SUBJECT: Comments on DRECP Draft EIS/EIR

This letter provides the comments of Soda Mountain Solar, LLC (SMS) on the Draft Environmental Impact Statement (EIS), and Environmental Impact Report (EIR) prepared for the Desert Renewable Energy Conservation Plan (DRECP), referenced herein as the DRECP Draft EIS/EIR.

SMS is the applicant for the Soda Mountain Solar project, a 350 megawatt solar electric generating facility proposed on public lands administered by the Bureau of Land Management (BLM) in the Soda Mountain Valley of San Bernardino County, California (SMS Project). The BLM received a right-of-way application for the SMS Project on January, 2008. The BLM case number for the project is CACA 49584.

Figure 1: DRECP Desert Tortoise Least-Cost Corridors With USFWS Recovery Units

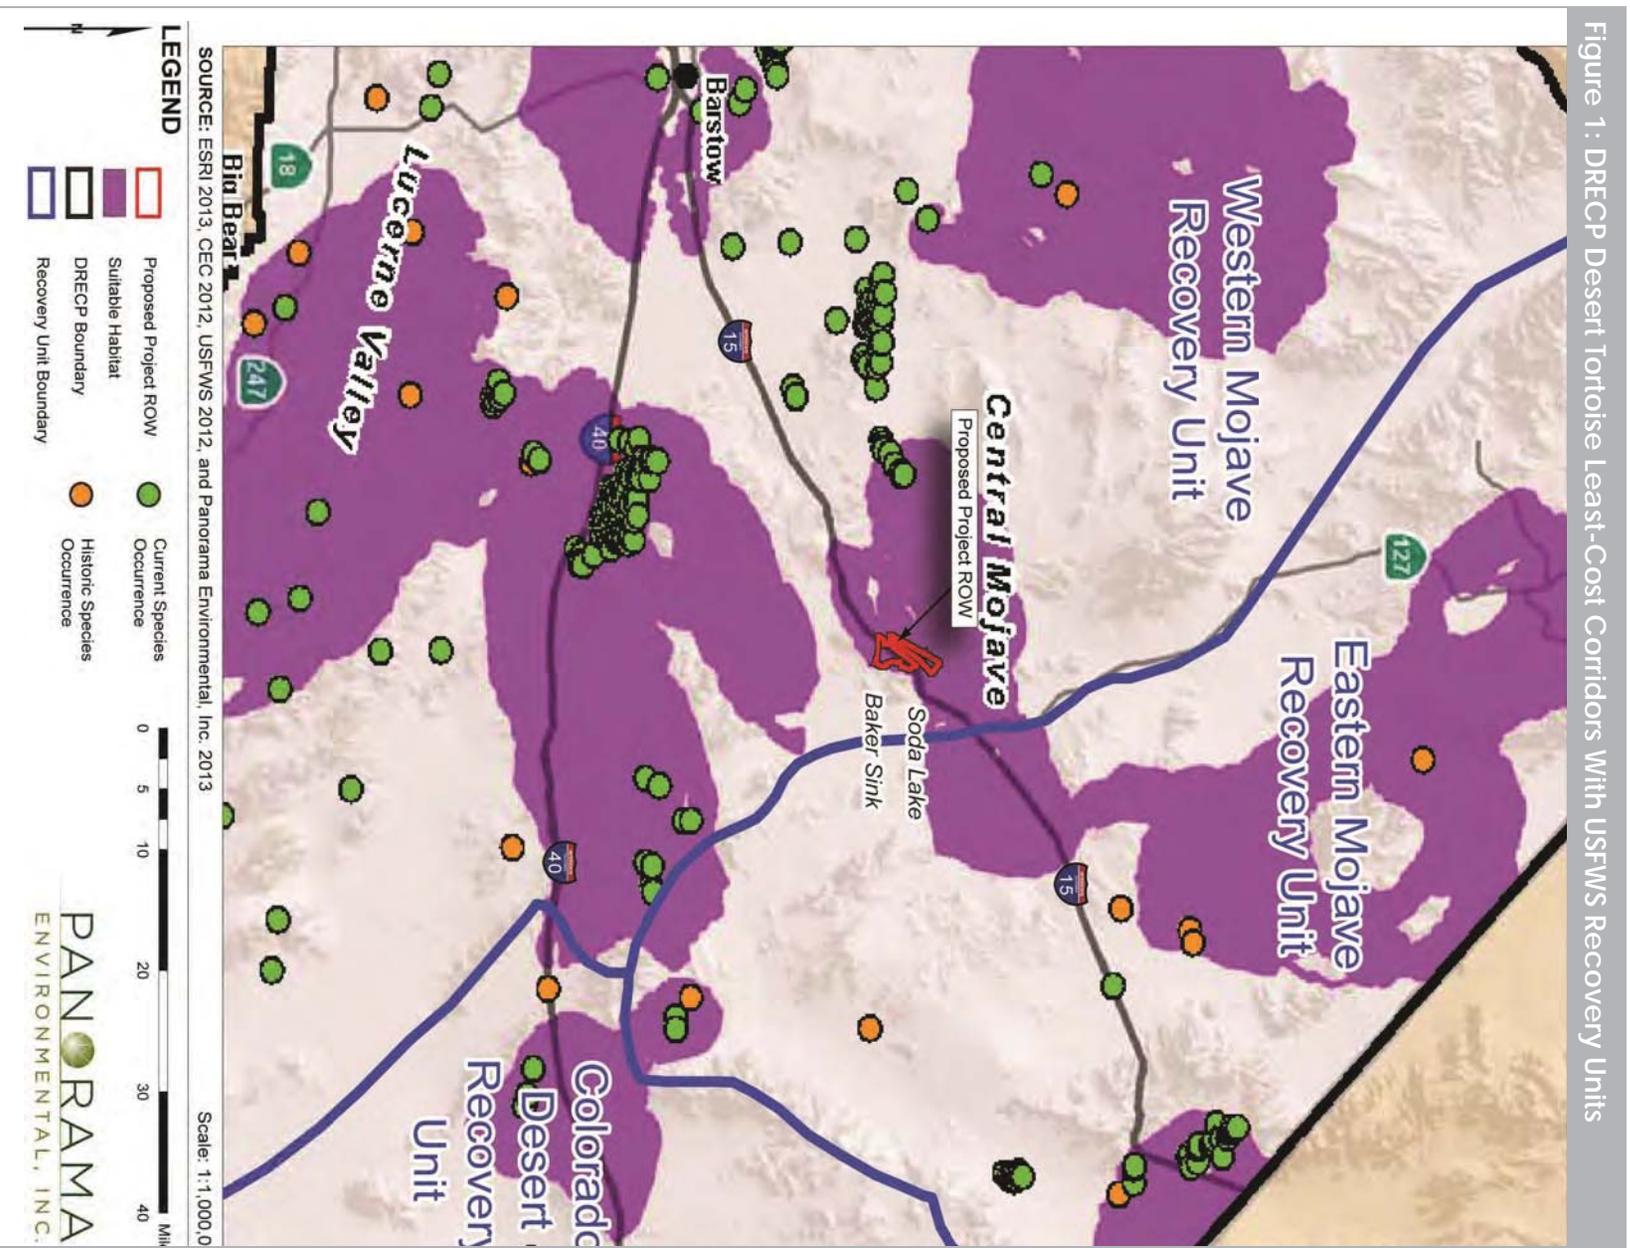
Figure SM-R3B, “Draft Species Habitat Model Results for Desert Tortoise (USFWS Least Cost Corridors)” shows the SMS project area as within a least-cost corridor for desert tortoise (Figure 1). This modeling was conducted by USFWS using the habitat suitability results of Nussear et al. (2009). SMS presented data in its DRECP comment letter dated July 23, 2012, that show the habitat suitability presented in Nussear et al. overstates the habitat value for the project area (Panorama 2012; attached hereto as Exhibit 1). This USFWS least-cost corridor (Figure 1) is inconsistent with Penrod et al. (2012), in which species-specific modeling was used to identify movement corridors (Figure 2).

The least-cost corridor identified in Figure SM-R3B appears to connect suitable habitat areas to USFWS critical habitat areas. In the case of the SMS project area, the USFWS least-cost corridor attempts to connect the Ivanpah critical habitat unit to the Superior-Cronese critical habitat unit. This attempt is ill-founded.

The designation of a least-cost corridor between the Ivanpah critical habitat unit and Superior-Cronese critical habitat unit is inconsistent with the *Revised Recovery Plan for the Mojave Population of the Desert Tortoise* (USFWS 2011), other studies, and the physical environment. The Mojave population of desert tortoise is divided into five recovery units in the Revised Recovery Plan (USFWS 2011). Recovery units were defined on the basis of geographic barriers that coincide with observed variation among tortoise populations (Ibid). The project area is located on the eastern edge of the Western Mojave recovery unit (Figure 1). The Ivanpah critical habitat unit is located in the Eastern Mojave recovery unit. A least-cost corridor in Figure SM-R3B extends through the SMS project area and crosses between these recovery units (Figure 1). This corridor contradicts the Revised Recovery Plan by asserting that there is existing, or possible, connectivity between the West Mojave recovery unit and the Eastern Mojave recovery unit even though their separate designation is premised on the basis of geographic barriers between them.

Figure 5: DRECP Bighorn Sheep Critical Linkage and SMS Project Area

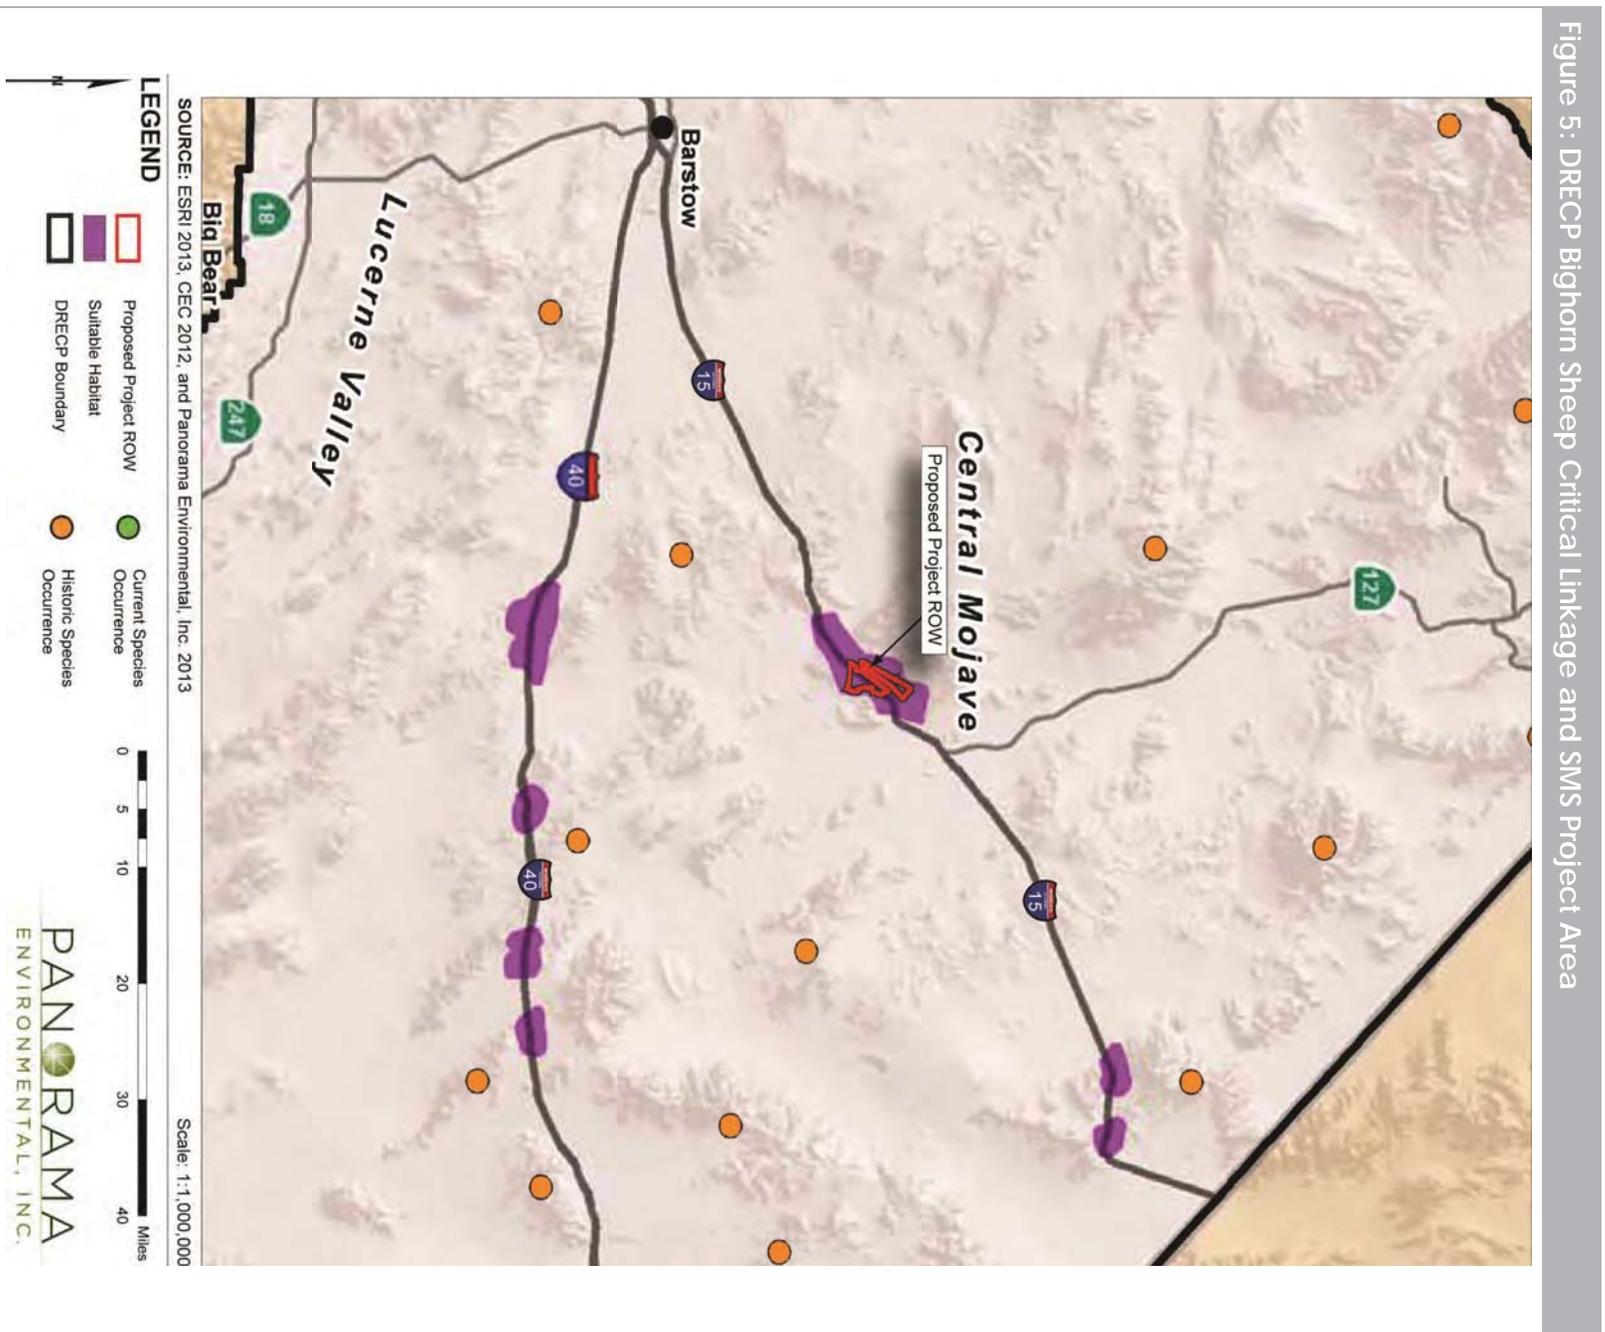
Figure SM-M1A, “Draft Species Habitat Model Results for Bighorn Sheep (Critical Linkage)” shows the SMS project area within a critical linkage for bighorn sheep (Figure 5 in this letter). The Alternatives Analysis does not include assumptions used in the model development, and does not specify the methods or criteria that were applied to determine the “critical linkages.” Section 3.1 of the Alternatives Analysis indicates Mountain and Intermountain Habitat models were developed by CDFW and John Wehausen. Appendix C of the Alternatives Analysis states that a proxy model was used but provides no additional information. The bighorn sheep model assumptions and methodology must be provided so they can be analyzed. Additional time should be allowed to review and comment after the model information is provided to reviewers.

The DRECP Critical Linkage Map (Figure 5) is Unsubstantiated and Should be Deleted because I-15 is a Substantial Barrier

The DRECP-modeled mountain and intermountain habitat depicted in Figures 7 and 8 reflects current and potential habitat use in the project vicinity fairly well. It is unclear why a separate delineation of “critical linkages” in Figure 5 is needed or what supports the delineation. The intermountain habitat results more accurately identify locations where bighorn sheep could connect between core mountain habitat areas. We suggest removing the critical linkage map because it is unsubstantiated and does not reflect the results of the more precise modeled mountain and intermountain habitat. If the critical linkage map is not removed, at a minimum it

would need to be updated to reflect the reality that I-15 is not permeable except for at specific overpasses and underpasses where conditions are suitable for bighorn sheep crossing, which is essentially the conclusion drawn in Figure 6 of this comment. I-15 experiences near-continuous traffic in the SMS project area. Bighorn sheep would be struck by vehicles if they were to attempt to cross the highway at locations other than the specified overpasses or underpasses. Figure 5 fails to take this into account and ignores the viability of movement through the underpass at Zzyzx Road.

Figure 2: Soda Mountain Solar “High Conflict Areas”

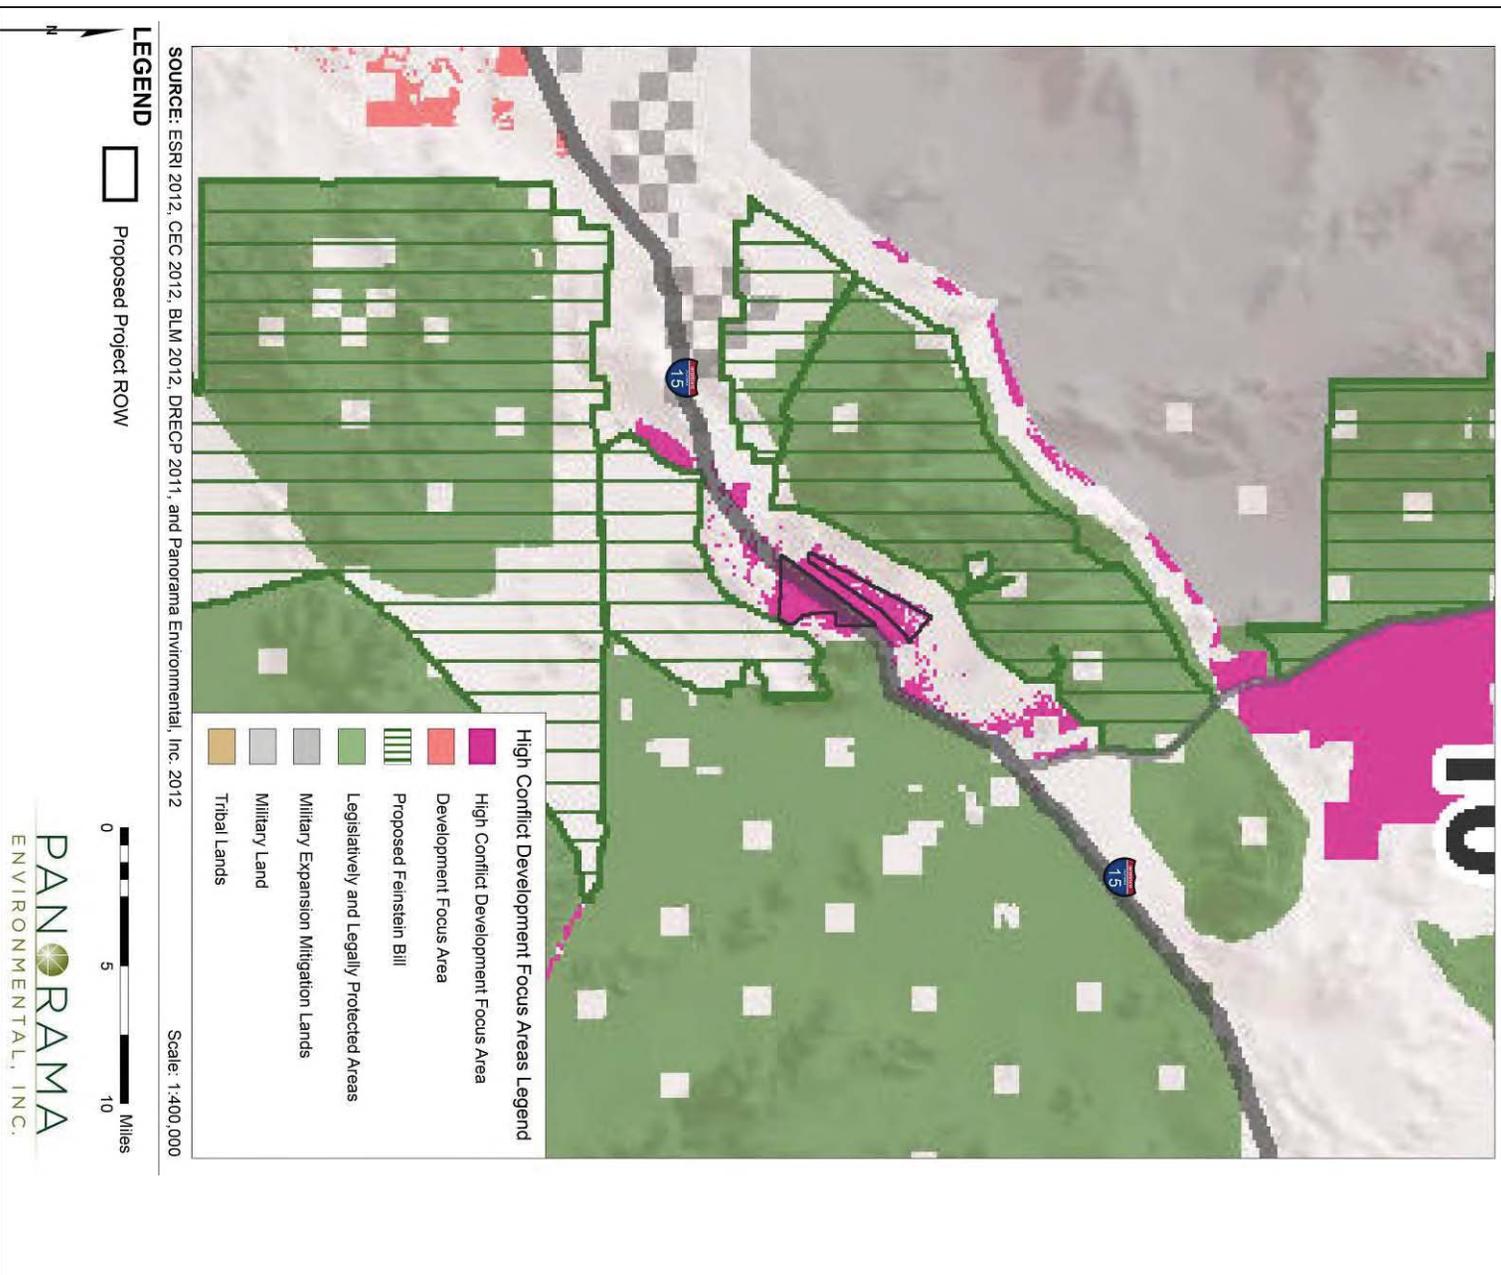
The Project site, consisting of approximately 4,400 acres, is included in a larger potentially high conflict area. The majority of the Dinosaur polygon is located north of the Soda Mountains in an area that is geographically separate from and includes different habitat elements than the Project site. The conflicts identified for the Dinosaur polygon do not apply to the Project site. The Project site does not contain Mojave fringe-toed lizard modeled habitat, and, as shown in Figure 3, is not located within any habitat linkages (CEC 2012 and Penrod et al. 2012), or habitat identified by intensive surveys (URS 2009). The modeled results for designating desert tortoise and bighorn sheep habitat inaccurately characterize and overstate the habitat suitability of the Project site because focused surveys for desert tortoise and bighorn sheep are in direct conflict with the model results. The surveys found no desert tortoise on the Project site and a lack of suitable habitat for bighorn sheep. As explained above, the models of desert tortoise and bighorn sheep habitat suitability overstate the habitat quality of the Project site.

In short, the High Conflict Area map needs to be revised to exclude the Project site because the potential biological and public land use conflicts ascribed to the Dinosaur polygon do not apply to the Project site.
